Planning Commission Staff Report

Project Type: Amended Site Development Concept Plan

Meeting Date: April 28, 2014

Description: **Mercy Health Systems:** An Amended Site Development Concept Plan, Amended Conceptual Landscape Plan and Amended Tree Preservation Plan for a 43.35 acre tract of land zoned “UC” Urban Core District located north of Chesterfield Parkway East, south of Interstate 64/US Highway 40 (SE Quadrant).

Figure 2: Proposed Amended Site Development Concept Plan

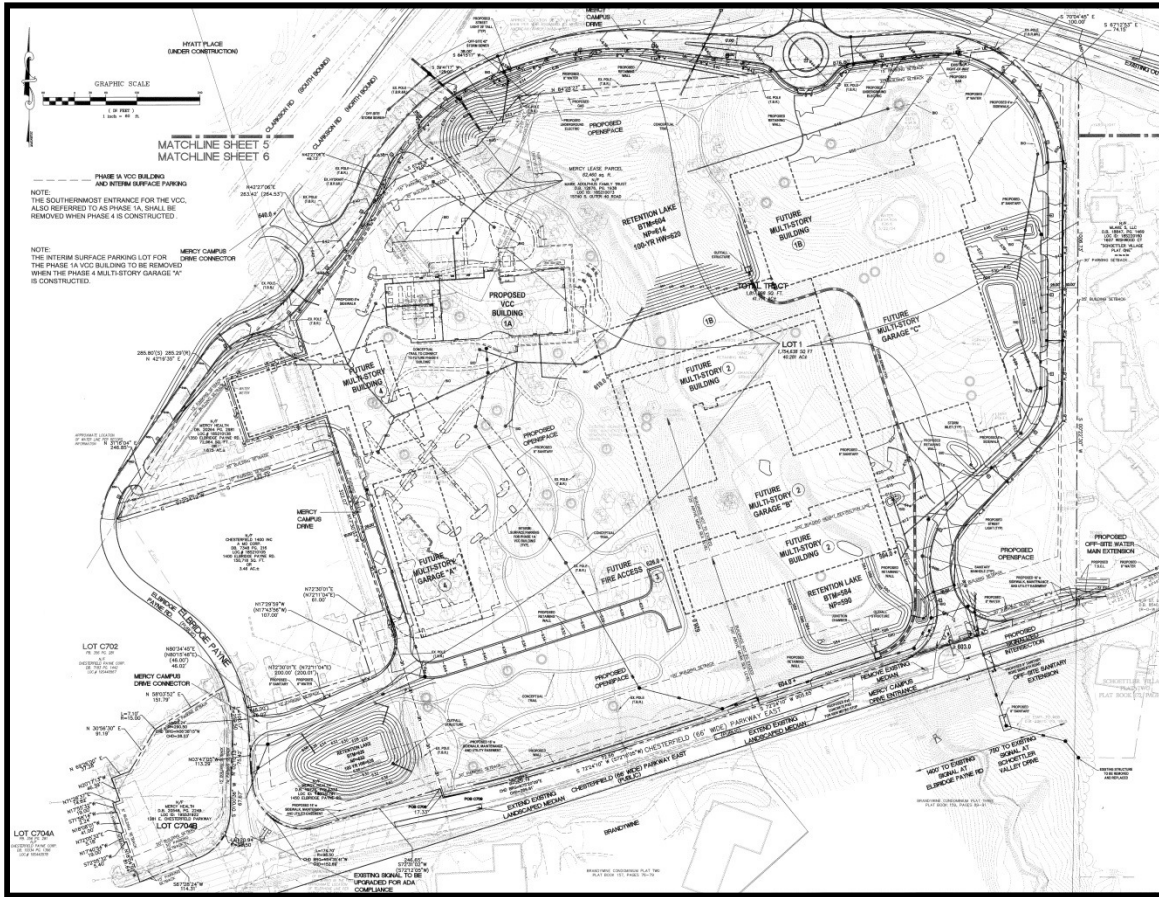
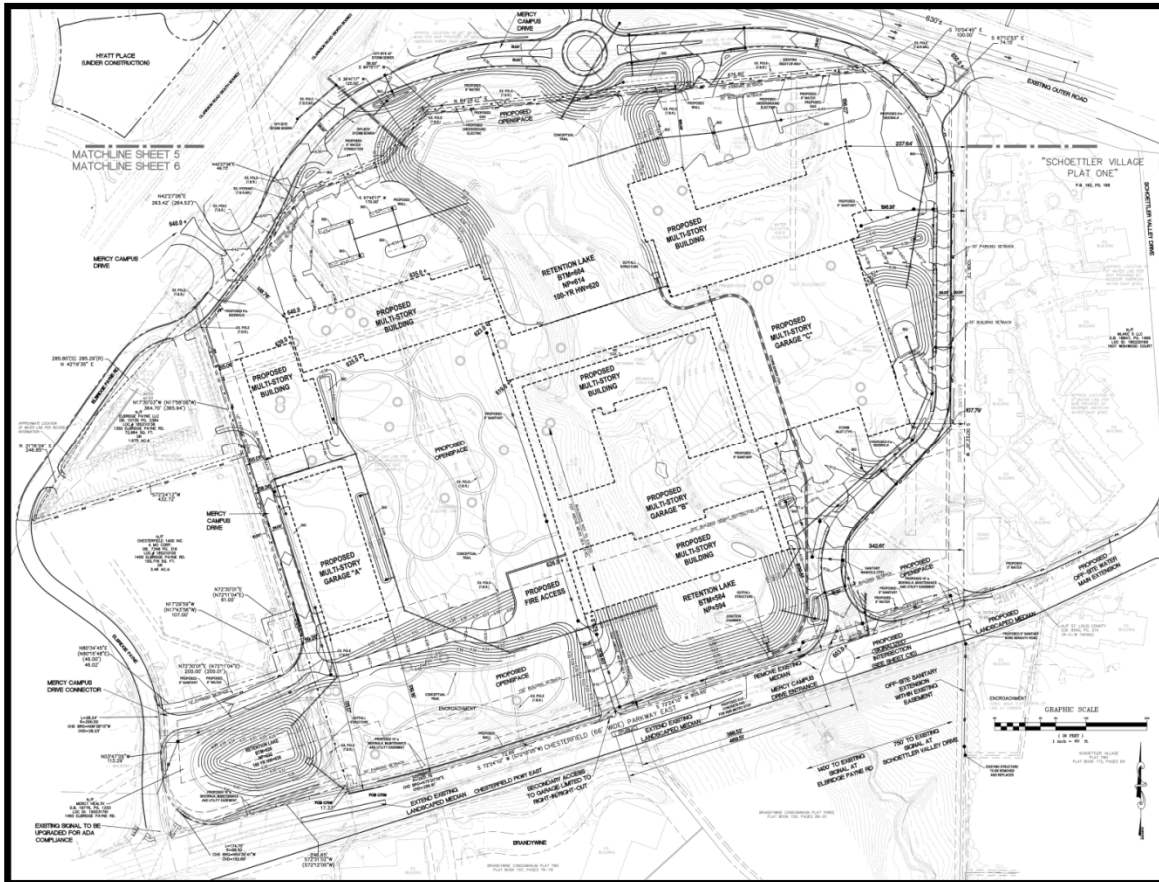
As seen in Figure 2 and Figure 3 below, the major differences between the approved and proposed Concept Plans are on the western portion of the site. This is mainly due to the addition of the 1350 Elbridge Payne Road parcel to the development. The proposal includes taking down the existing “triangular building” and adding a multi-story building in an “L” shape as Phase 4 of the development. The second major change is the proposal of surface parking for Phase 1A of the development which will be removed when the parking garage is built in Phase 4. And finally there is an entrance proposed on the southwestern portion of the site as part of Phase 1A of the development (near 1350 Elbridge Payne Road) which was not shown on the approved Site Development Concept Plan. However, similar to the surface parking, this entrance will be removed when Phase 4 of the development is constructed.
